# MPCP Timestamp Jitter with Idle Deletion/Insertion

Marek Hajduczenia ([marek.hajduczenia@zte.com.cn](mailto:marek.hajduczenia@zte.com.cn))

ZTE Corporation

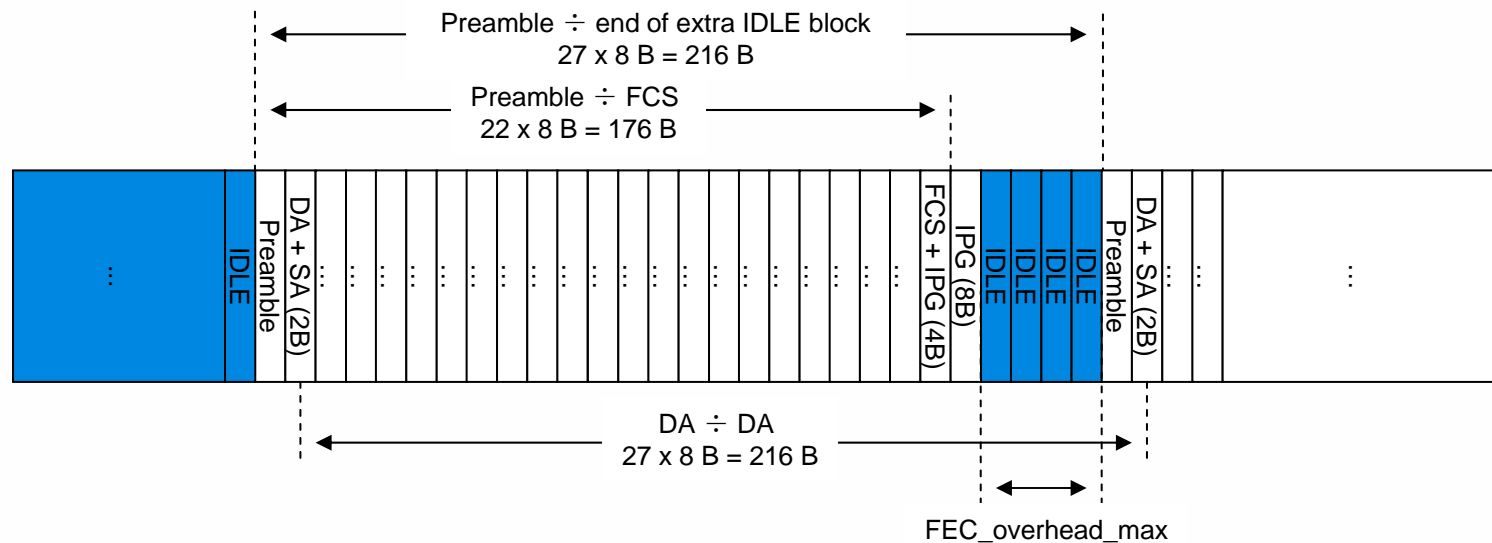
### ■ Actual behaviour of MPCP timestamp jitter:

- Despite detailed analysis of state diagrams / their operation, there is still significant MPCP timestamp jitter observed for certain sizes of frames;
- MPCP timestamp jitter seems to become frame-size dependent (worst situation possible)

- Examine the potential sources of MPCP timestamp jitter
- Attempt to eliminate them or at least make MPCP timestamp jitter independent from frame size

### ■ What happens at Idle Deletion function:

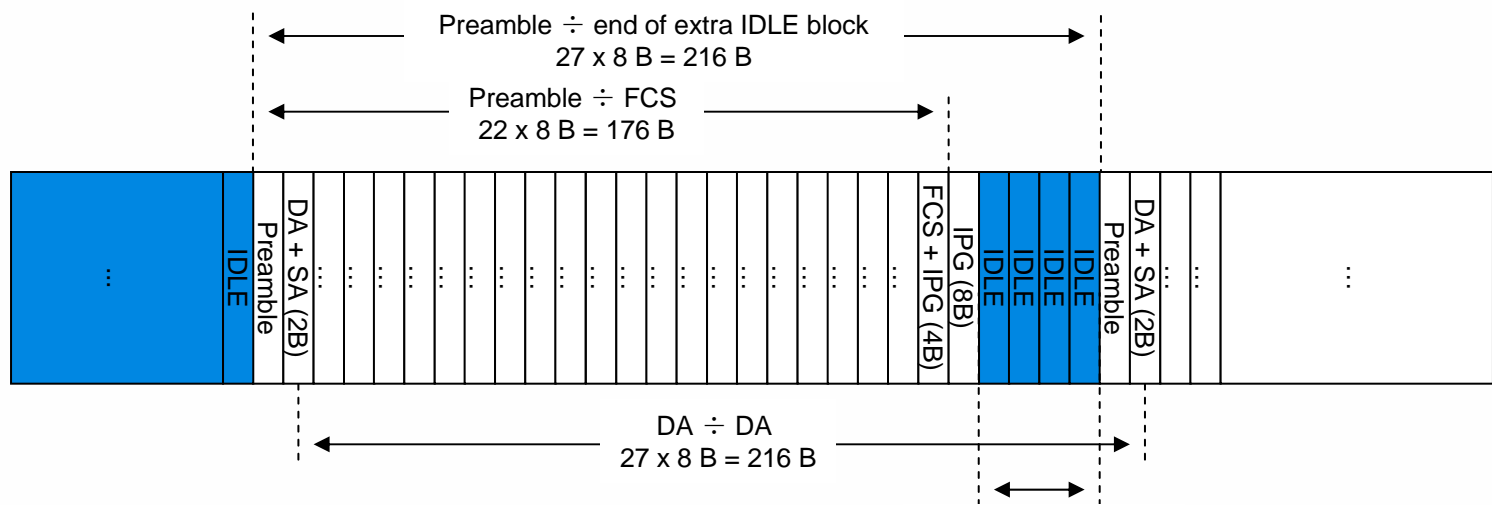
- VectorCount and DelCount are 0 at the first preamble word (assume last packet ended clean and variables were reset after its transmission)
- VectorCount = FEC\_DSize at the word right before the 2<sup>nd</sup> preamble, DelCount is set to FEC\_PSize (4) only after transmission of FEC\_DSize vectors;
- The next clock is the 2<sup>nd</sup> preamble word (not (C+E)), the DelCount cannot be deducted here.
- Idle deletion is delayed to the end of the next packet.
- After idle deletion, the distance of the two DAs is still  $27 \times 8 \text{ B}$

### ■ What happens at FEC Encoder function:

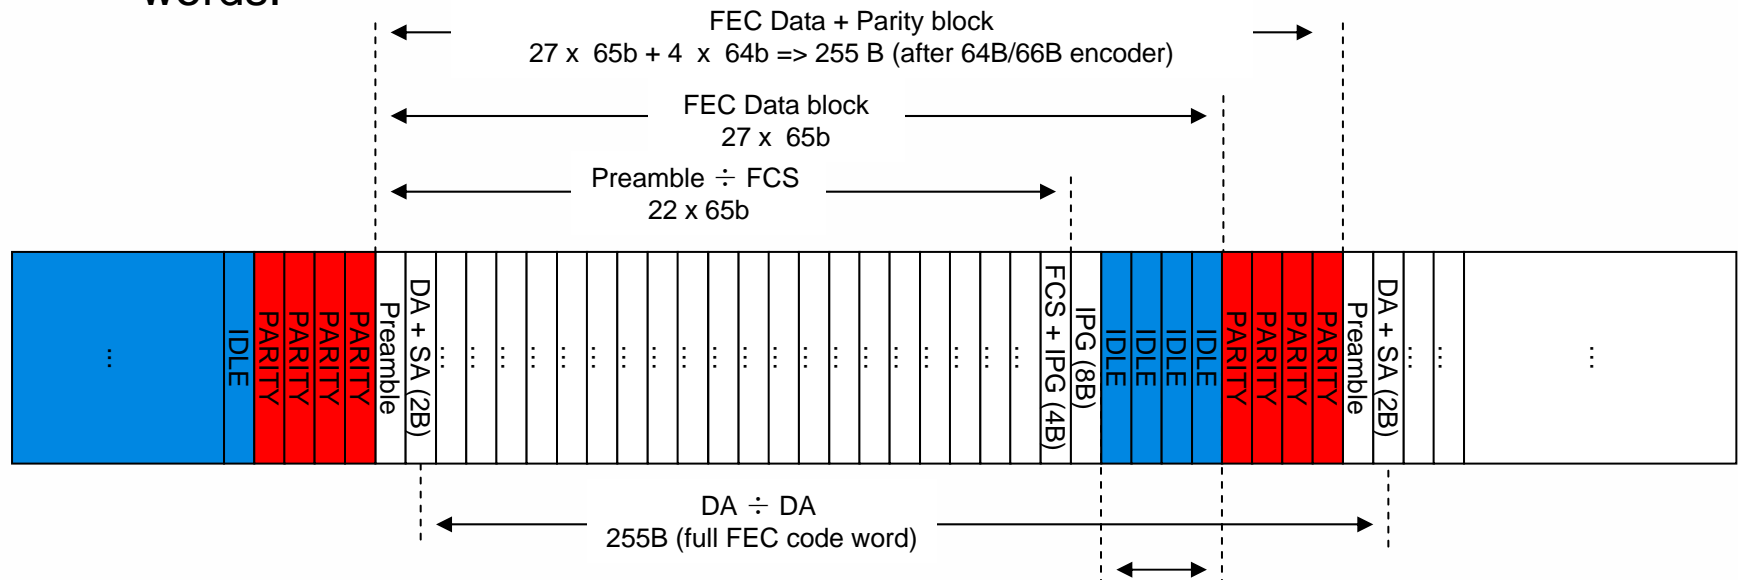
- An FEC encoding boundary starts right at the first preamble word;
- The 4 words reserved as FEC parity by `FEC_overhead_max` are not removed and are counted as the FEC data words;
- Before the 2<sup>nd</sup> preamble word, 4 x 8 B blocks of FEC parity data need to be added - the distance between the two consecutive DAs becomes 31 words.

- Data passing FEC decoder should always have fixed delay
- Delay should also be independent from packet size
- The current Idle Deletion state diagram does not perform correctly under for packets of size 22 XGMII transfer columns (and smaller)
  - Occurs when bit 1 of preamble is aligned with start of FEC word
  - Extra IDLEs for FEC parity are not deleted correctly, forcing a data shift / loss at the FEC encoder (data might be overwritten)
  - Needs more testing under longer runs of constant packet sizes (might be important for CBR applications, where packet sizes are constant e.g. VoIP, certain VOD with specific codecs etc.)
- Up to  $4 * 6.4 \text{ ns} = 25.6 \text{ ns}$  can be introduced for RTT from one side of the link to the other. Is it considered ok for the RTT drift budget ?
- A fix seems to be simple – initialize DelCount with FEC\_PSize (currently not initialized at all)
